Kennedy Road Class Environmental Assessment Study

Steeles Avenue to Major Mackenzie Drive

Open House #2 – November 25 and December 2, 2019

Summary of Online Survey Forms and Emailed Comments

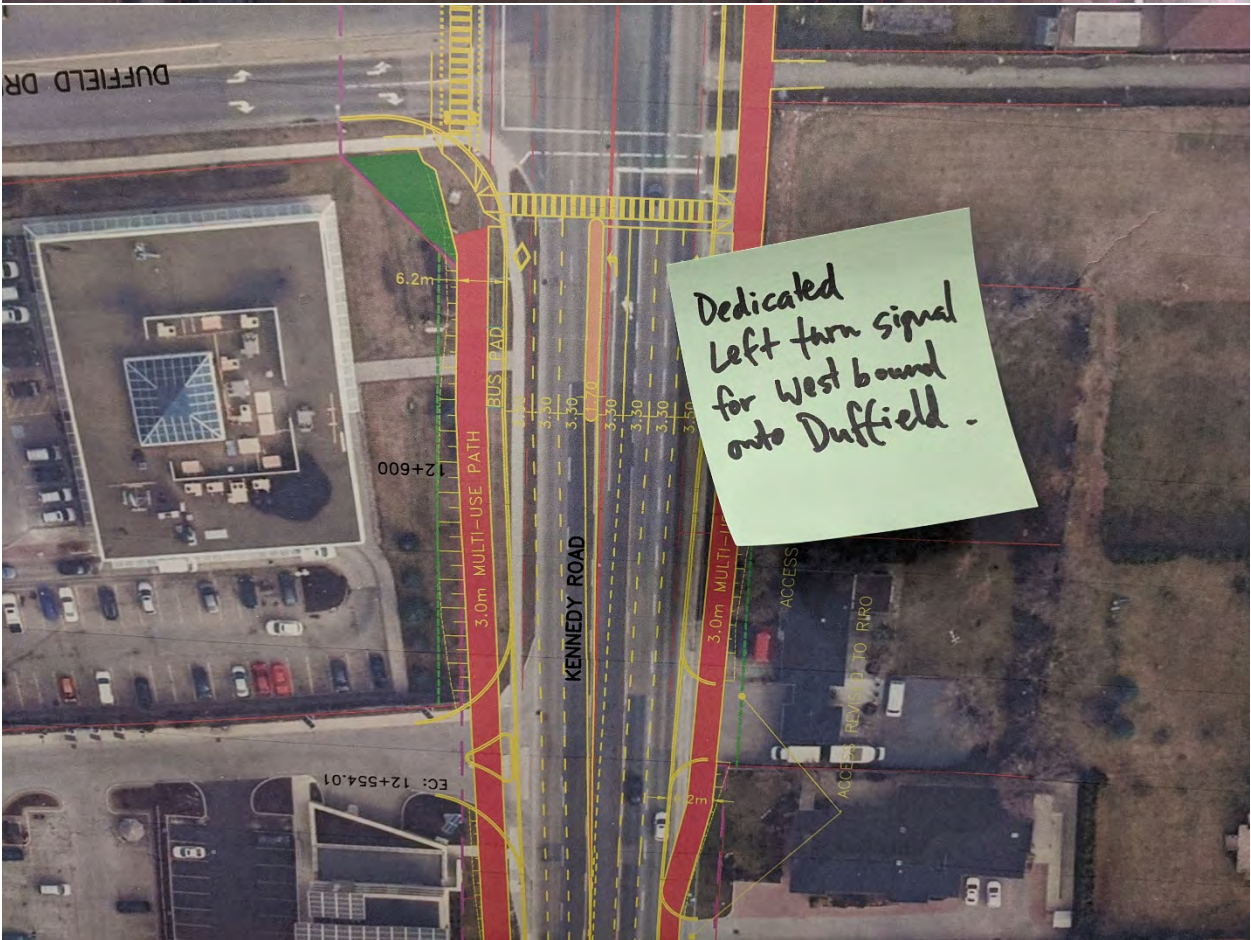
Design the "T" with
Duffield to
accommodate the
future road design
(c/w AT) of the
Miller Ave. extension.

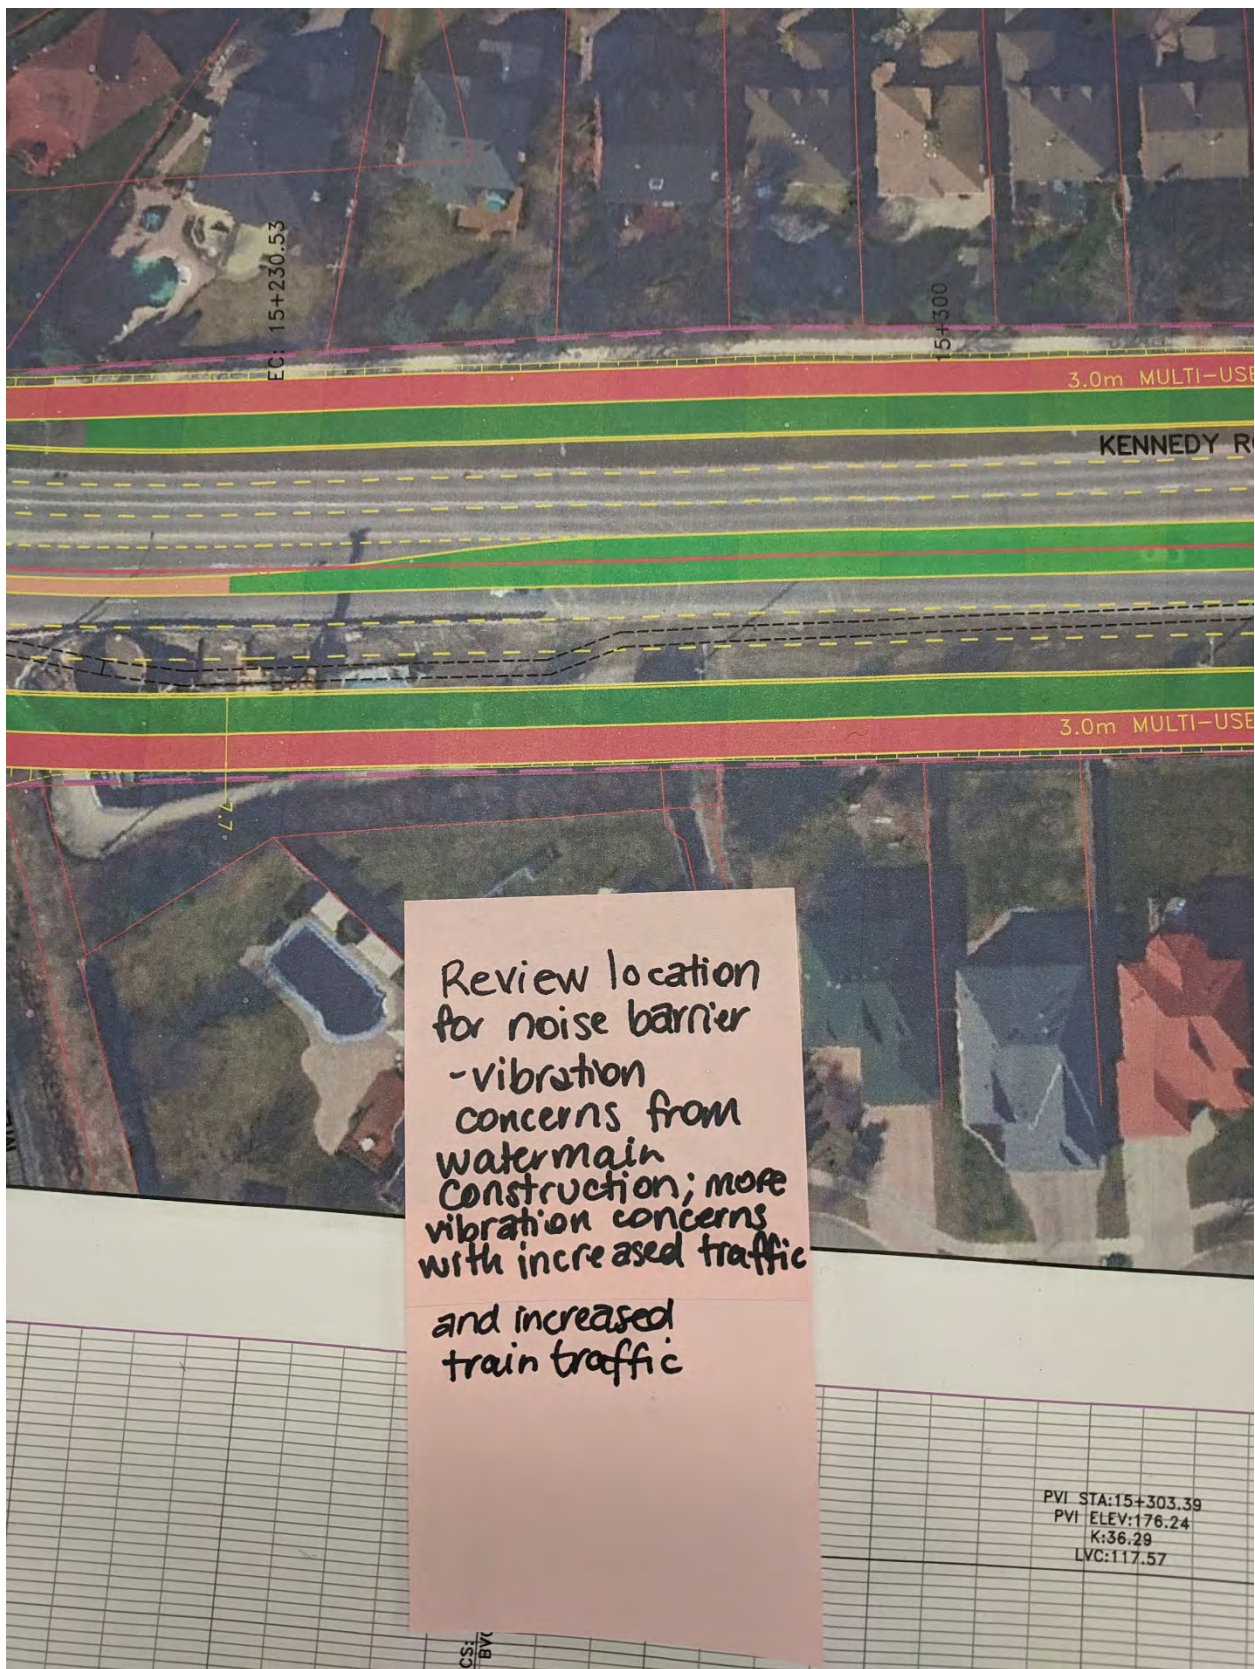
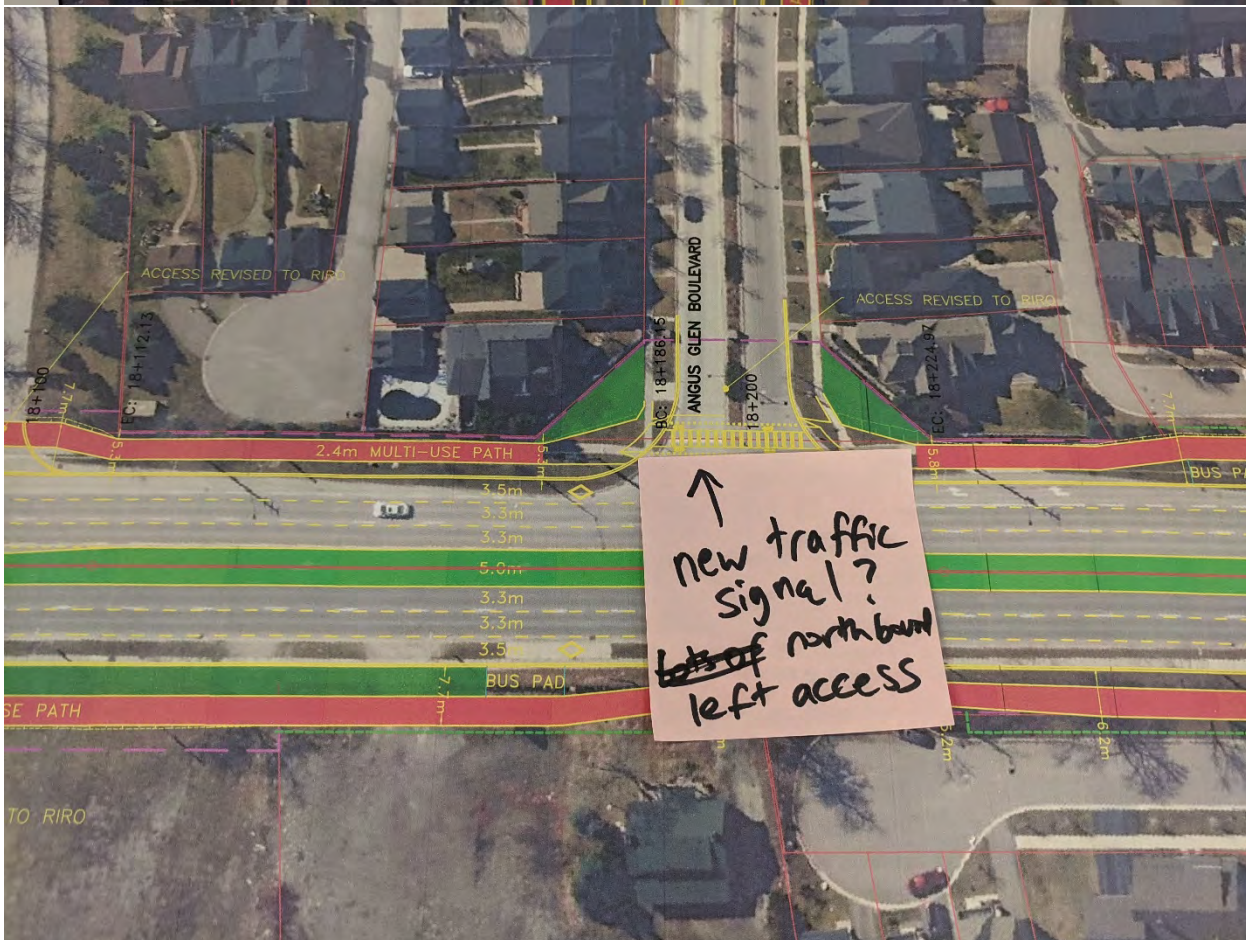
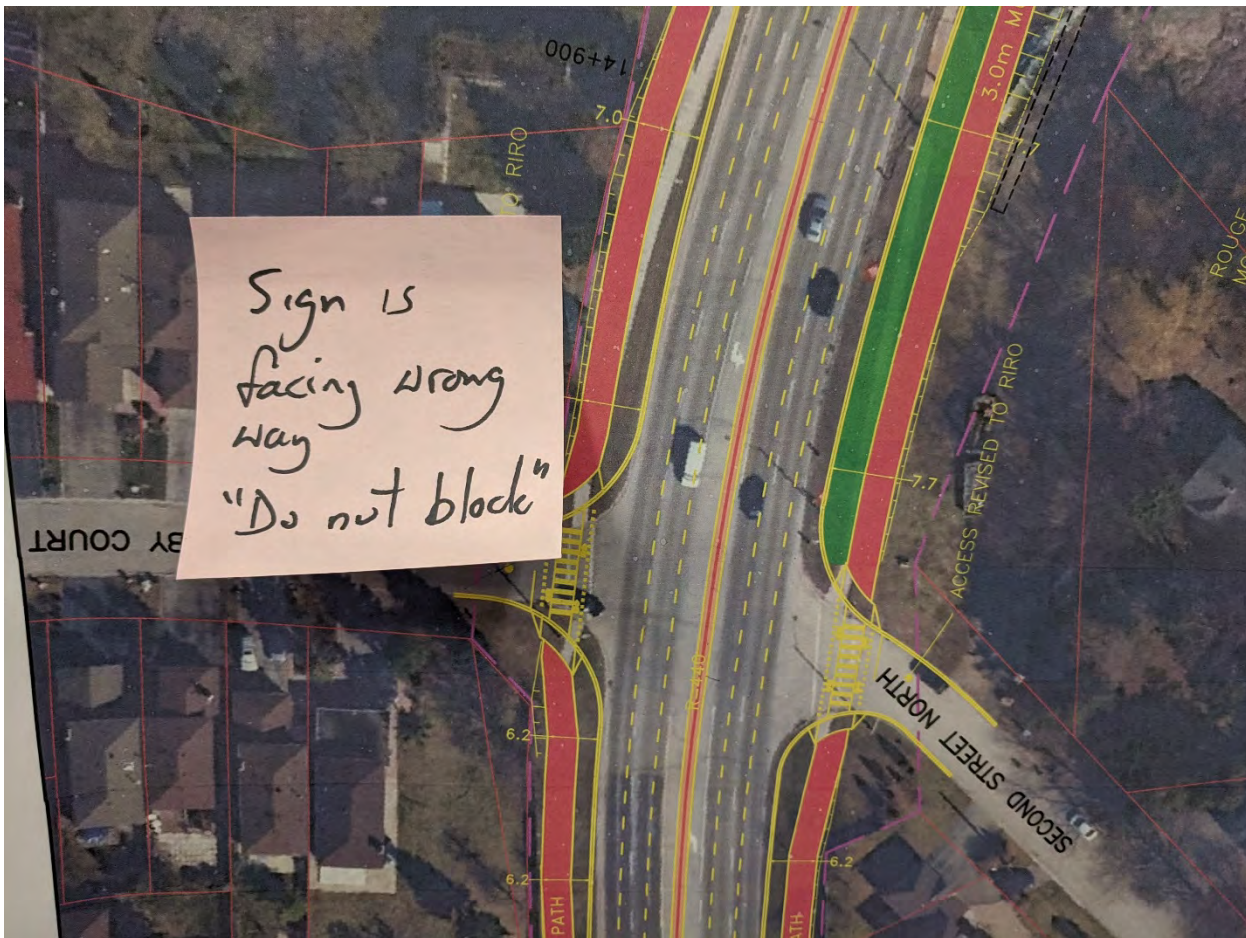
Dedicated
Left turn signal
for West bound
onto Duffield.
